Attachment 2 of 5 Northrop Grumman Comments on Proposed Amended Record of Decision and Feasibility Study

Modeling Memorandum

to Northrop Grumman Comments on Proposed Amended Record of Decision and Feasibility Study for Northrop Grumman Bethpage Facility and Naval Weapons Industrial Reserve Plant Modeling Memorandum

NYSDEC SCENARIO 5B LAYOUT

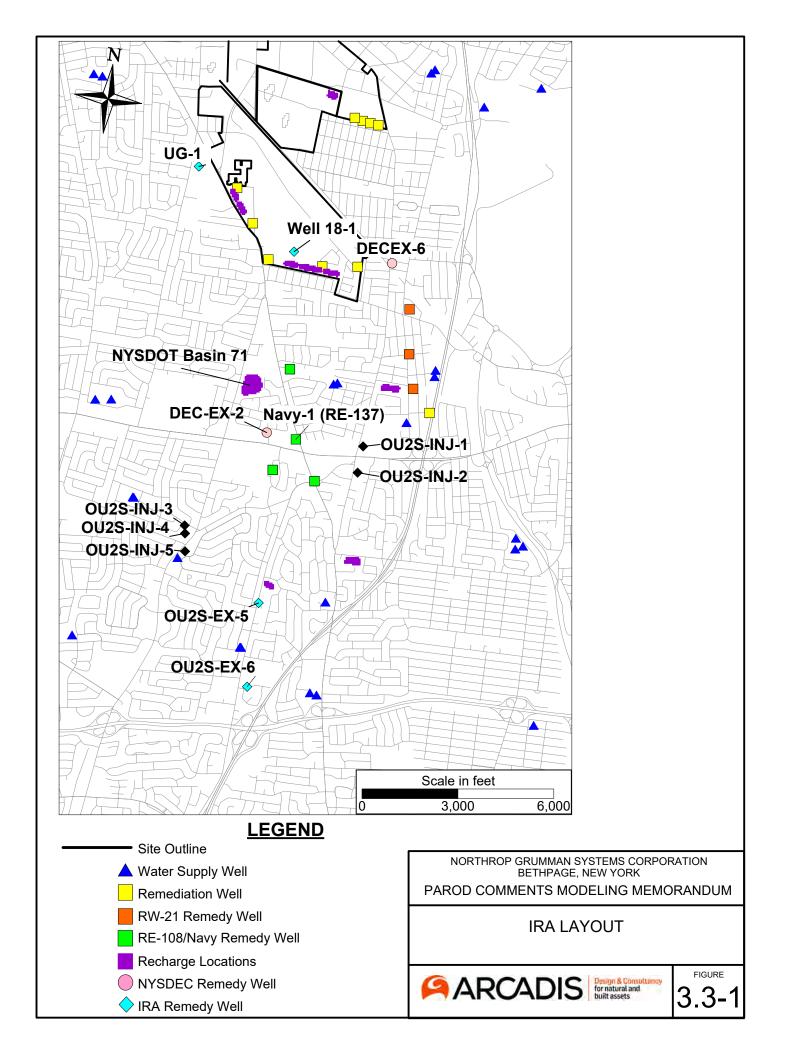
NYSDEC Scenario 5B has the following remedy components (see Figure 3.2-1; Table 3.2-1):

- All the pumping described in NYSDEC Scenario 1 (Section 3.1 of this memorandum).
- Eight mass flux remediation wells operating at 4,290 gpm total, expected to become operational in five years.

- Sixteen hydraulic containment wells operating at 7,850 gpm total, expected to become operational in five years.
- Treated groundwater is planned to be discharged to the following locations:

A consequence of NYSDEC Scenario 5B is the spreading of the northwestern portion of the plume from sources upgradient of the Site towards the south. This is due to the hydraulic effect of the new basin to be constructed in Bethpage State Park and the lack of an extraction well south of upgradient sources north of the Site. The large-scale discharge of treated water to the basin (and hence to the groundwater system) has a profound effect that results in pushing water away from it in a radial pattern. Under NYSDEC Scenario 5B, TVOCs in the northeastern portion of the plume are either captured by pumping wells or are hydraulically pushed to the west and southwest. A similarly shaped expansion is noted for NYSDEC Scenario 1; however, the expansion is much less severe than that noted for NYSDEC Scenario 5B as the NYSDEC Scenario 1 does not include the new recharge basin in Bethpage State Park. This expansion does not occur in the IRA, primarily due to the placement of a new remedial well just south of upgradient sources.

REMEDIATION EFFICIENCY - POUNDS OF TVOC MASS REMOVED PER BILLION GALLONS OF WATER PUMPED AFTER 30 YEARS OF SIMULATION: NYSDEC SCENARIO 1

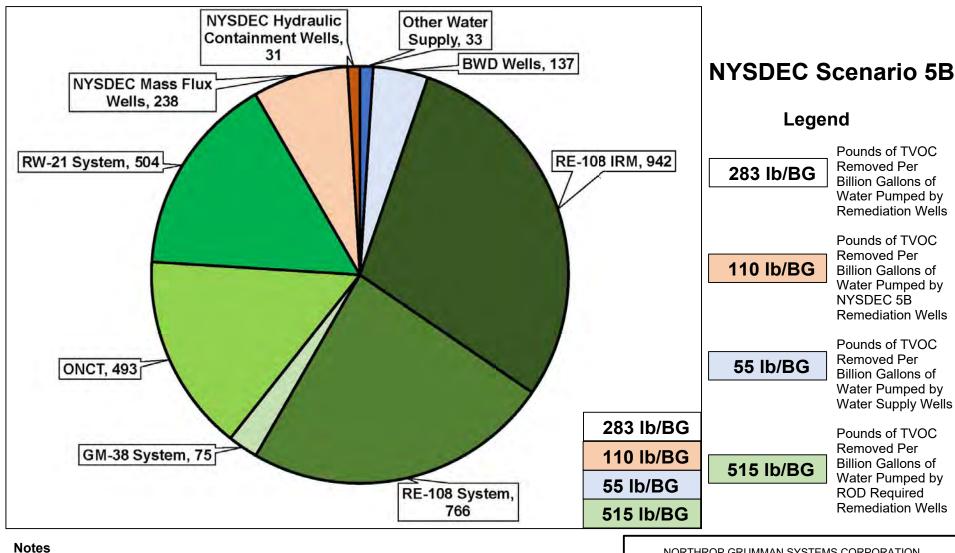
The remediation efficiency (mass removed per billion gallons of water pumped) for different well groups are shown on Figures 4.2-7 to 4.2-9 after 30 years of simulation. The mass removed per billion gallons of water pumped is the total mass extracted by the well group after 30 years of simulation divided by the total amount of water pumped by the well group after 30 years of simulation. The remediation efficiency for all remediation wells is 609 pounds per BG (lb/BG) for NYSDEC Scenario 1, 283 lb/BG for NYSDEC Scenario 5B, and 522 lb/BG for the IRA. Therefore, the wells operated for NYSDEC Scenario 1 and the IRA are significantly more efficient for remediation than the wells operated for NYSDEC Scenario 5B. The

remediation efficiency for public water supply wells are similar for each scenario (82 lb/BG for NYSDEC Scenario 1, 55 lb/BG for NYSDEC Scenario 5B, and 63 lb/BG for the IRA). Therefore, protectiveness of public supply wells is similar under NYSDEC Scenario 5B and the IRA, and both show benefits over NYSDEC Scenario 1.
